To: Chris Nosbich – City of Mount Vernon, IA
From: Ben Wilkinson, PE, and Nathan Cook
QA/QC: Mark Lenters
Subject: IA 1 at US 30
Roundabout In-Service Review
Date: June 13, 2018

MSA was tasked by the City of Mount Vernon to provide an in-service review of the multi-lane roundabout at IA 1 and US 30 in Mount Vernon, IA. There is concern that the roundabout is experiencing higher than normal number of crashes, albeit, mainly property damage only (PDO) type crashes.

EXHIBIT 1.0

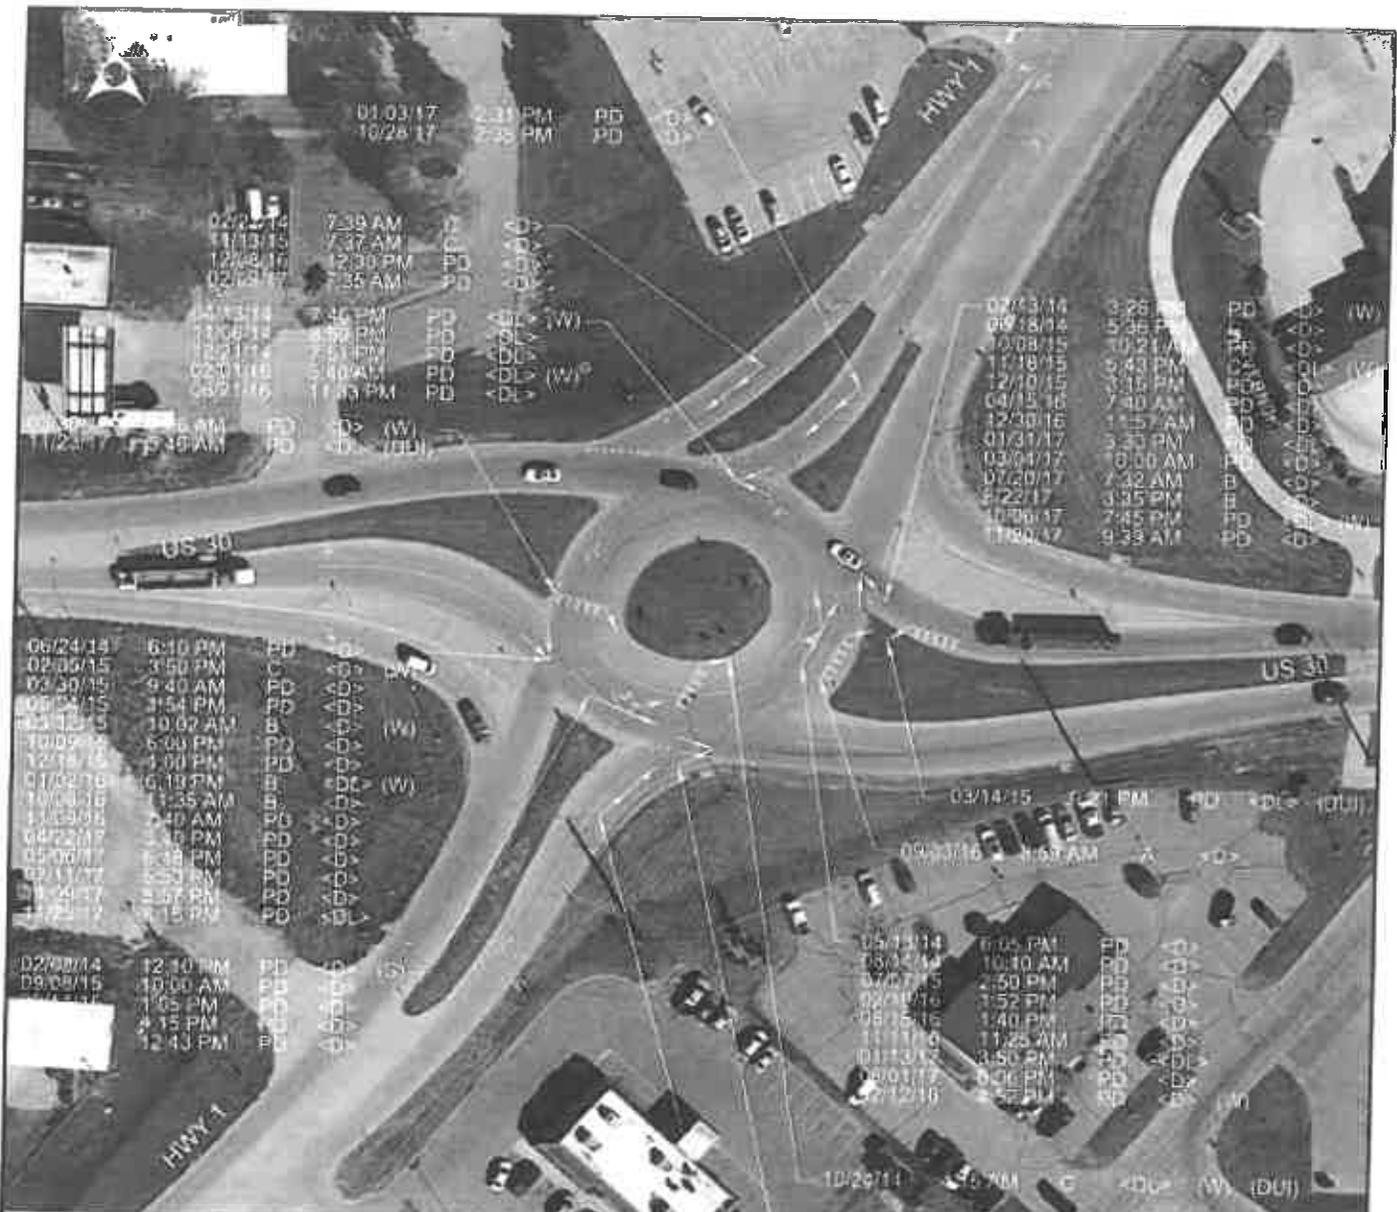
Mount Vernon police retrieved crash data for this intersection from January 2014 through February 2018 (4.17 years). Within this period, 70 crashes were analyzed. Of the crashes on record, there were 43 angle collisions, 14 sideswipes, 5 fixed objects, and 8 rear-end collisions. Fifteen (15) crashes involved injuries, and no crashes involved a fatality. The total crash rate for the intersection is 2.2 crashes per million entering vehicles (MEV) and 0.5 crashes/MEV for injury type crashes. For comparison, a recent study of 32 similar multi-lane roundabouts in Wisconsin showed an average of 0.8 crashes/MEV and 0.14 injury crashes/MEV. Eleven (11) of the 70 crashes involved semi-trucks, which accounts for 16 percent of the total crashes. On average, there are 2.6 crashes per year involving semi-trucks; this is higher than expected since truck traffic only makes up 8 to 9 percent of the total traffic present at the intersection. See Table 1 for a summary of the manner of collisions occurring at the intersection. A complete collision diagram can be found in Exhibit 1.0.

Figure 1. 2018 Existing Peak Hour Turning Movement Volumes

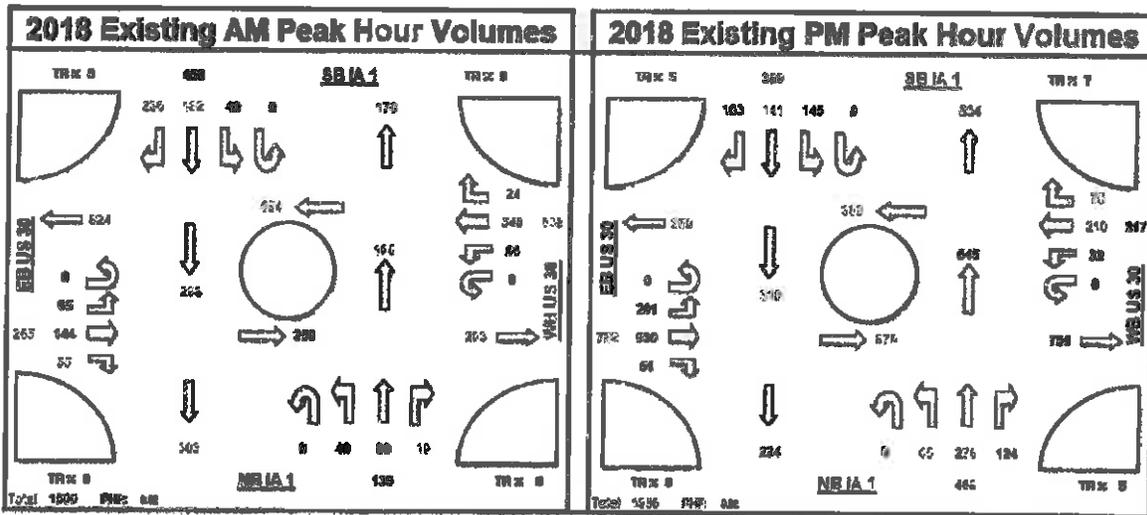
The existing roundabout was analyzed in Junctions 9 (ARCADY) and HCS 7 roundabout design and capacity analysis software. ARCADY (Assessment of Roundabout Capacity and Delay) is a program based on U.K. empirical research into geometry-capacity relationships. Two features that ARCADY provides are its ability take into account horizontal geometric design sensitivity and its ability to be calibrated. These two features are critical to accurately modeling the in-service roundabout to determine expected operations for any proposed roundabout geometric modifications. It was determined that a 5% capacity reduction factor was required to calibrate the software to match field observations of queues for the AM and PM peak hours. Turning movement counts were provided by the Iowa Department of Transportation (IaDOT) are shown in Figure 1.

Figure 2. 2040 Adjusted Design Year Peak Hour Turning Movement Volumes

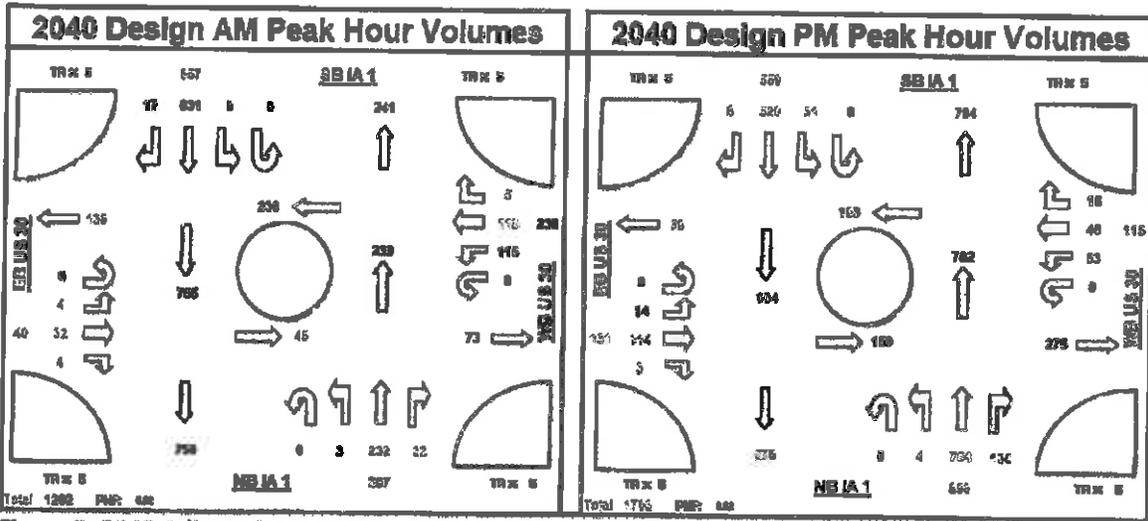
The single lane roundabout was analyzed for design year 2040. Additionally, the roundabout was analyzed for existing year 2018 to determine if the countermeasure could be implemented immediately or have to wait for the US 30 bypass to be opened. Adjusted design year turning movement volumes were provided by the Iowa DOT and are shown in Figure 2.

Figure 10. Example Median Screening Plans (Source: Oakland County Road Commission, 2016)

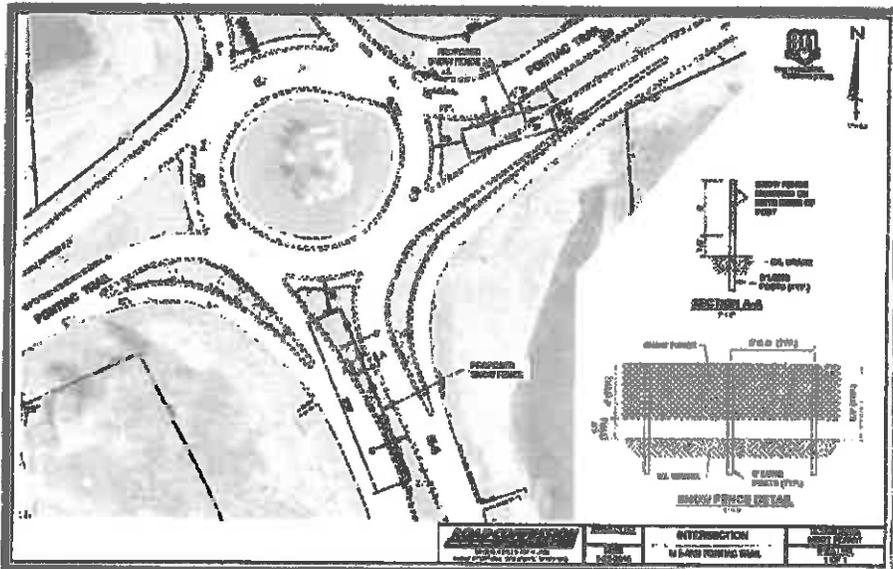
Installing planting or screenings in the medians on all approaches will help to promote yielding at entry. As described in the U.K. roundabout design guide, "in some circumstances excessive forward visibility at entry or visibility between adjacent entries can result in approach and entry speeds greater than desirable for the intersection geometry". Restricting sight to the left requires drivers to further reduce speed on approach before making a decision if there is an appropriate gap to enter or not. This restriction reduces driver's tendencies to "fly" into the roundabout when operating in off-peak periods. Screenings should be installed to allow for a minimum vision area of 50 feet back on the approach and upstream entry. Examples of plantings and screenings can be seen in Figure 9 and Figure 10. The version of screening applied in Oakland County in 2016 generated a 9 mph reduction in the 85th percentile speeds. It is too soon to conclude that their pilot study measure has been successful, but in the U.K., this measure has been applied to successfully reduce entry-circulating collisions.

Figure 11. WisDOT Central Island Typical Section

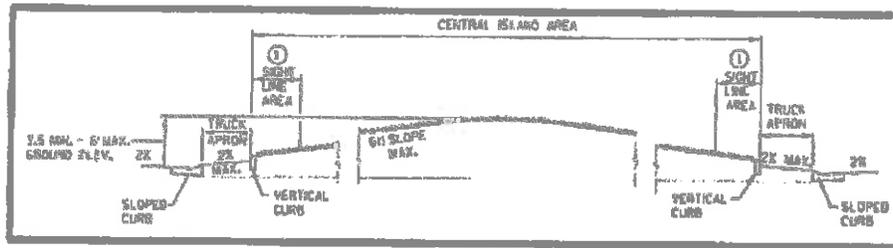
Additionally, the central island should be mounded and include plantings that grow tall enough to restrict sight across the roundabout. This will help to alert drivers of the approaching roundabout further in advance and give the roundabout more definition and aesthetics. See Figure 11 of a typical cross section of the central island used by the Wisconsin DOT.

Recommended plants should be salt tolerant and have a mature height of around 3 feet. Examples of these types of plants include, but are not limited to, Alpine Currant, Fragrant Sumac, Jackmanni, or Winged Euonymus.

Figure 13. Example of a Destination Sign Type

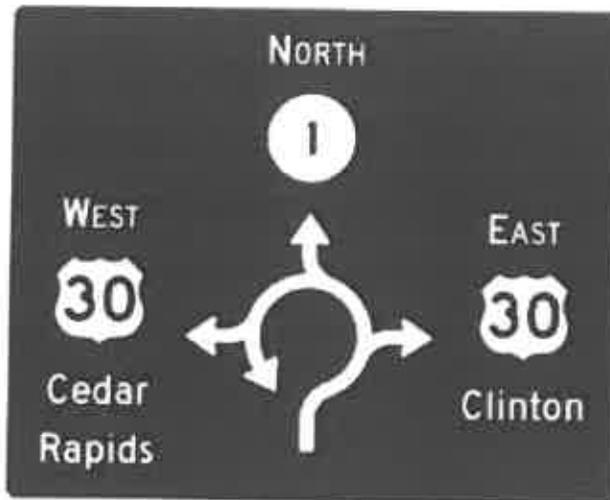
An alternative low-cost and immediate solution is to enhance approach signing. With approval of the Iowa DOT destination sign types (D1-5), as shown in Figure 13, should be installed on all approaches in place of the current route directional signs (M series). These signs help to give better advance warning of the approaching roundabout, as well as, destination and route guidance. With the large percentage of semi-truck related crashes involved at the roundabout a warning sign that identifies that trucks can use both lanes, such as the example in Figure 14, could be installed on the eastbound and northbound approaches where this is problematic. Yield signs could also be enhanced with LED Indicators to enforce the need to yield on entry, see Figure 15.
